2024-023 ITB
Janitorial Services
Addendum No. 1 September 3, 2024

This Addendum consists of 5 pages. Questions and answers from voluntary site visit, sign in sheet for voluntary site visit, and MOAB Elevation drawings.

ELEVATIONS

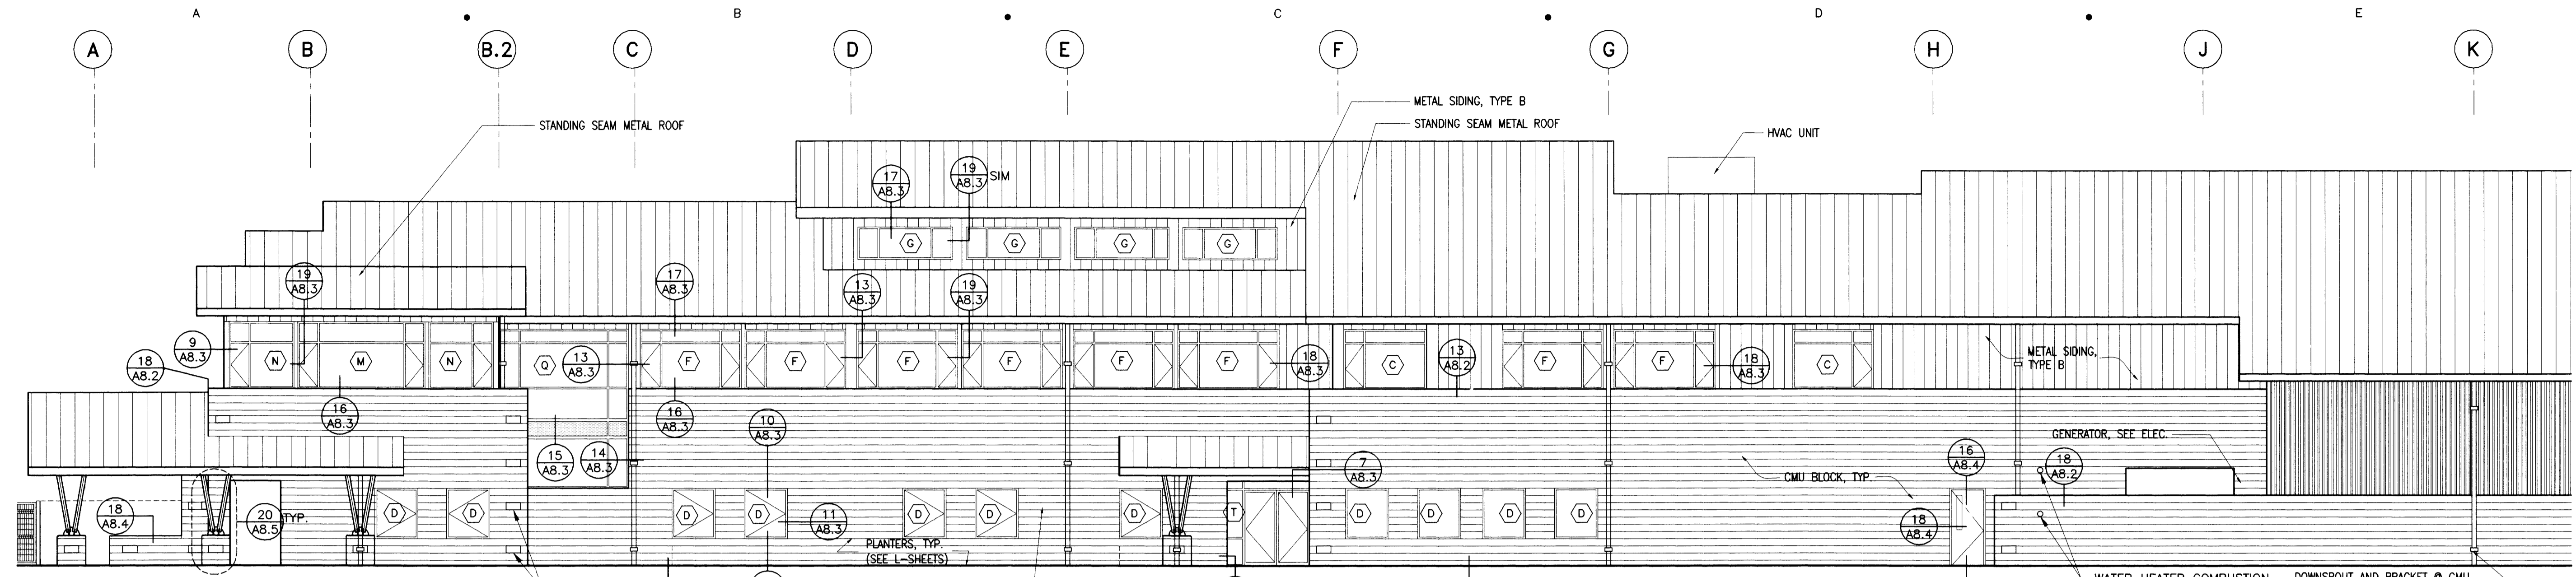
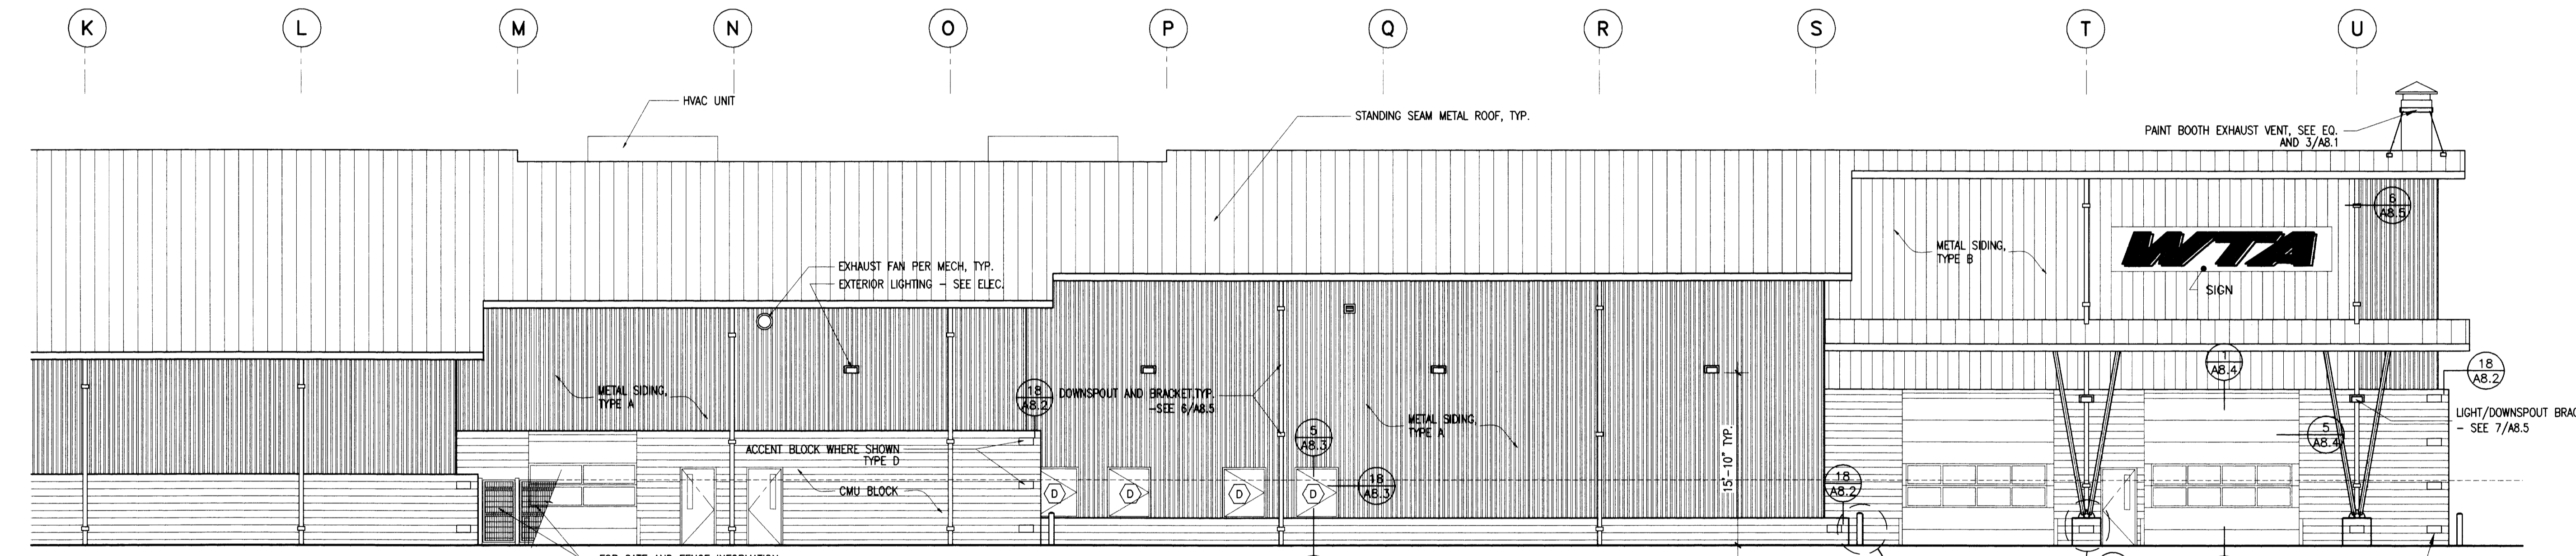
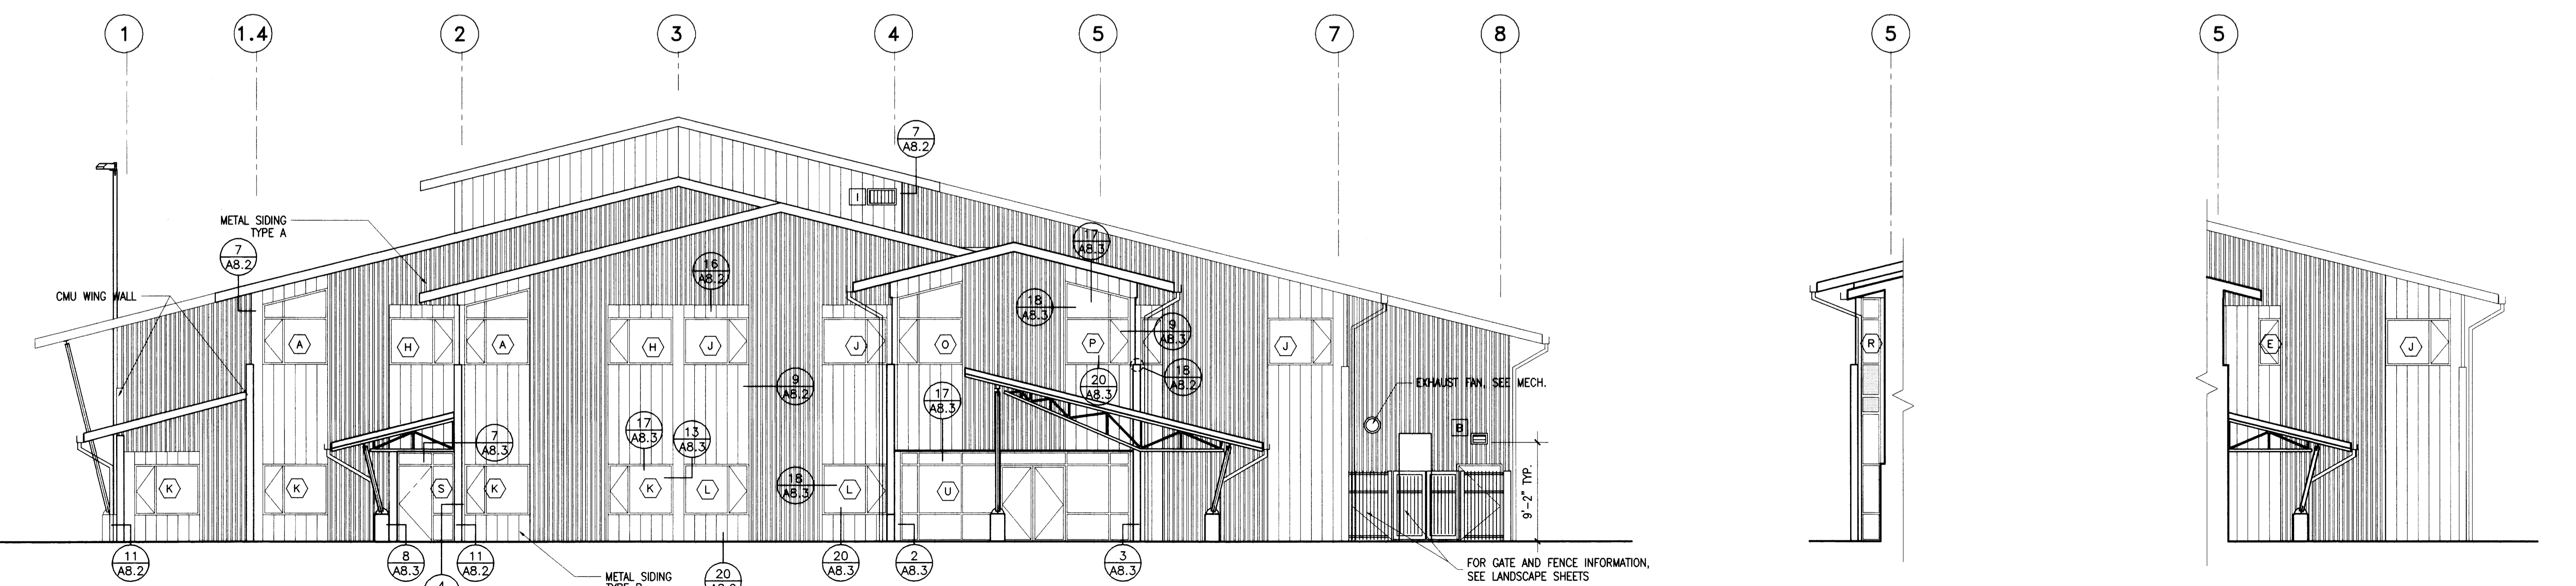
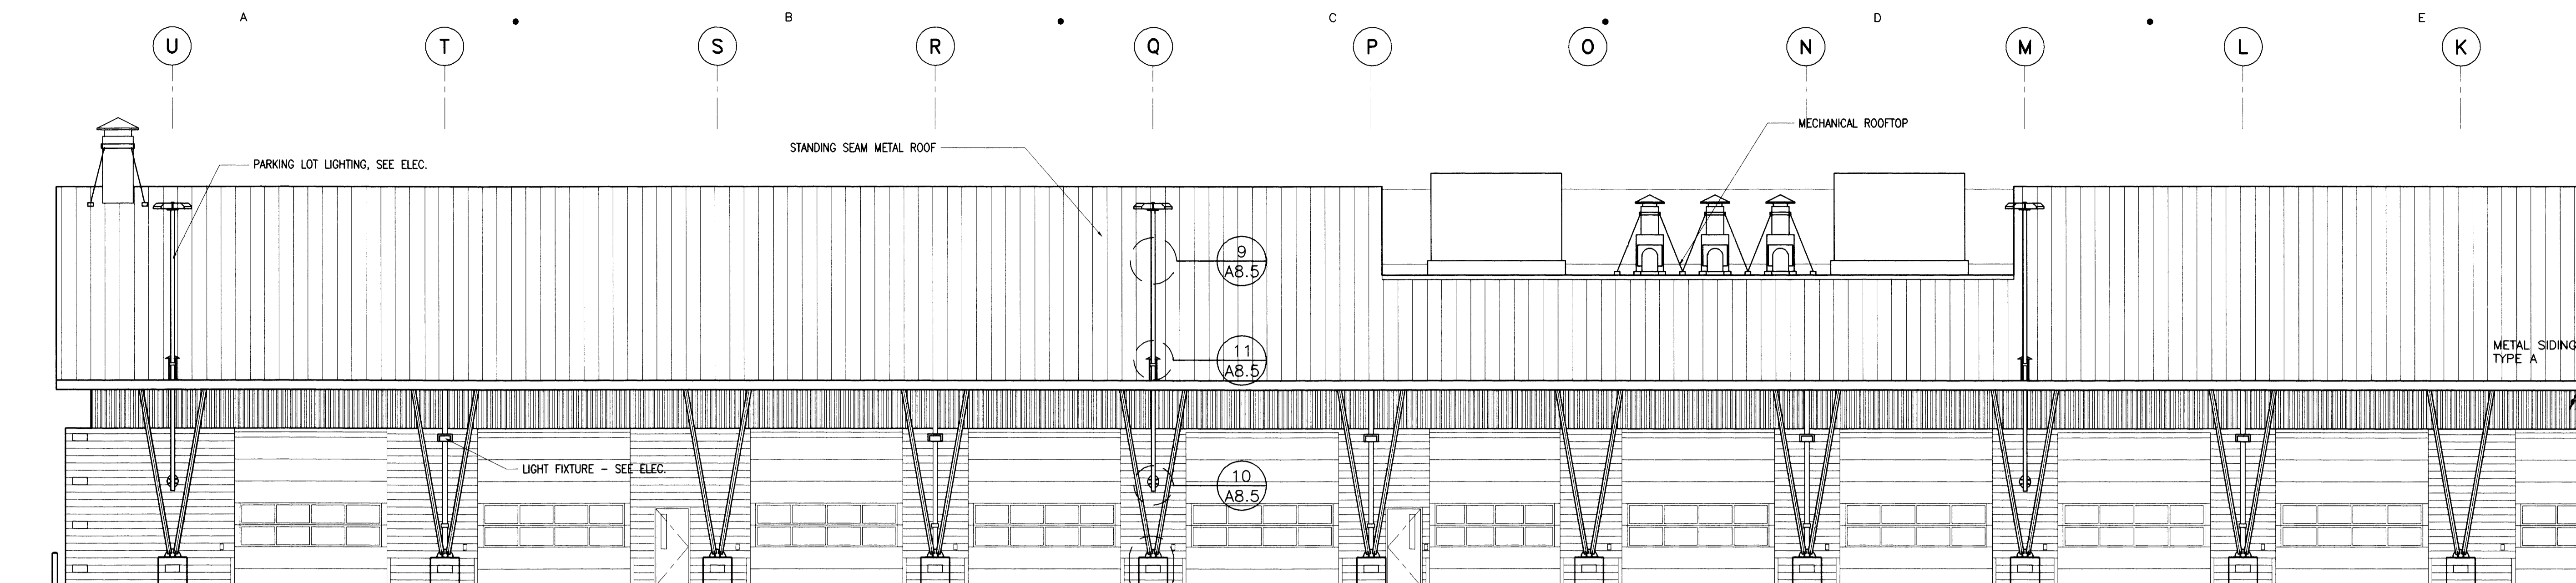
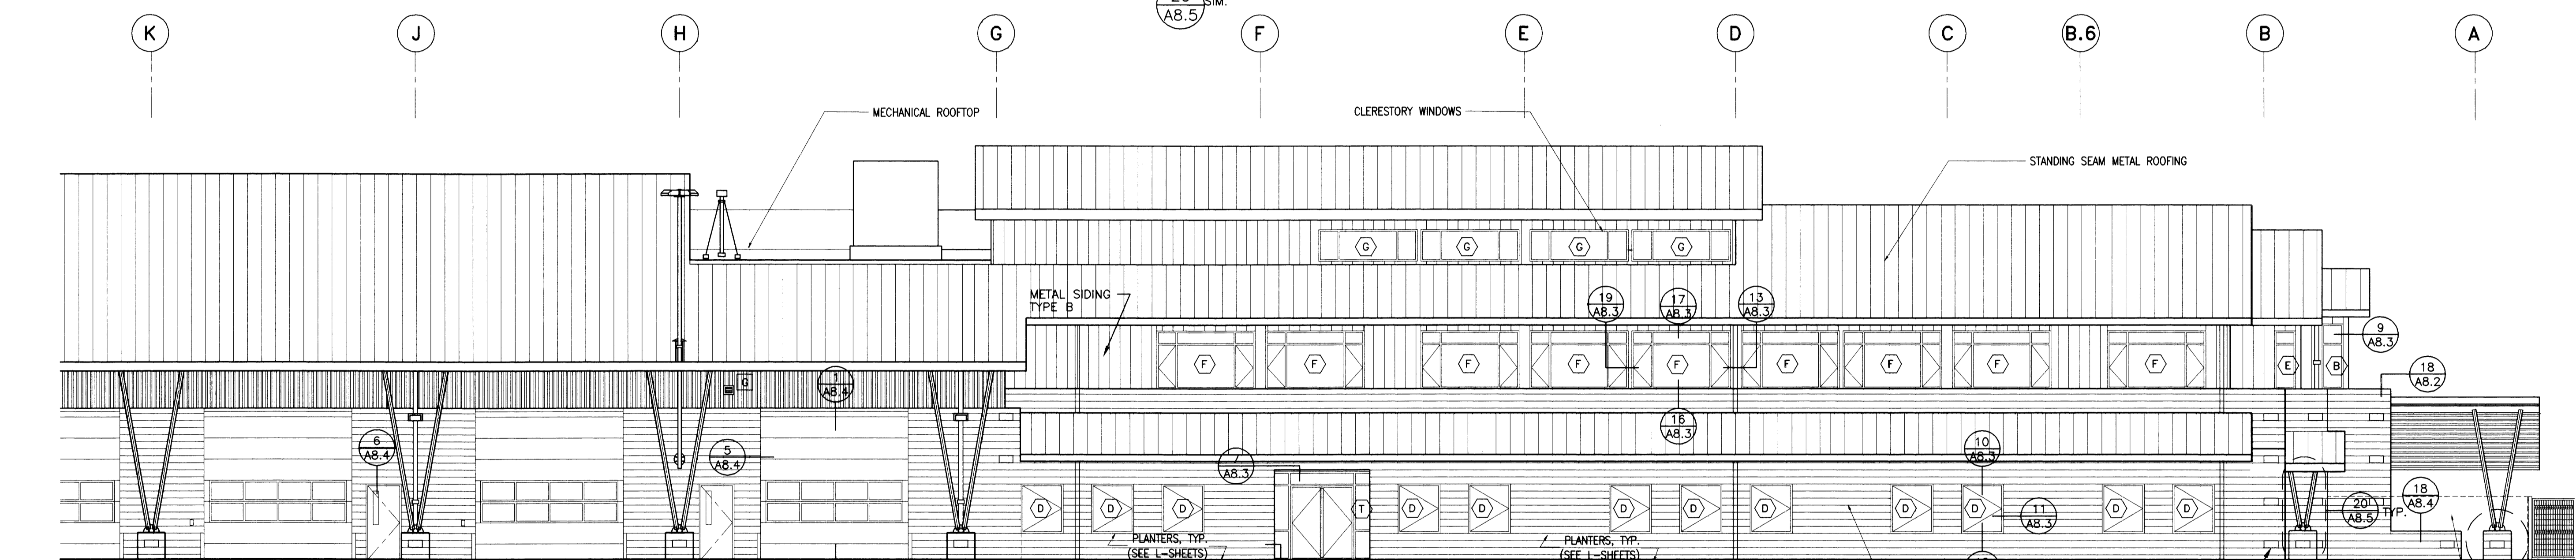
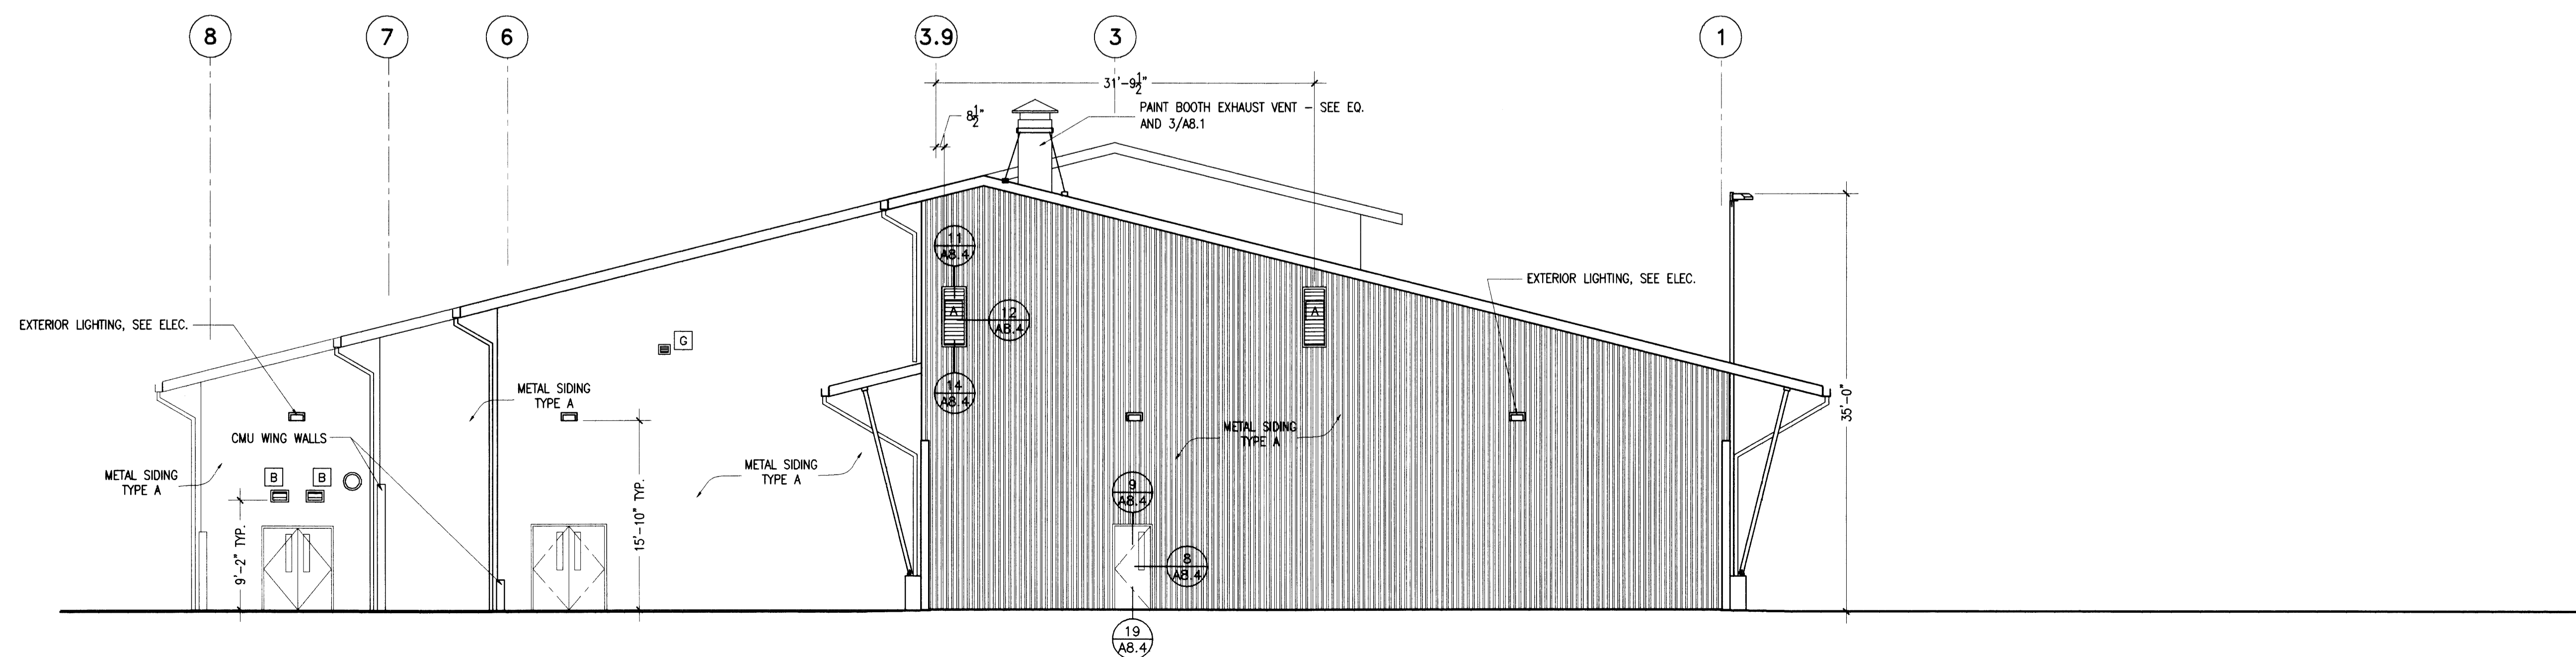
Q.) What is the count of high exterior windows?

A.) *Please see attached drawings for exterior window information.*
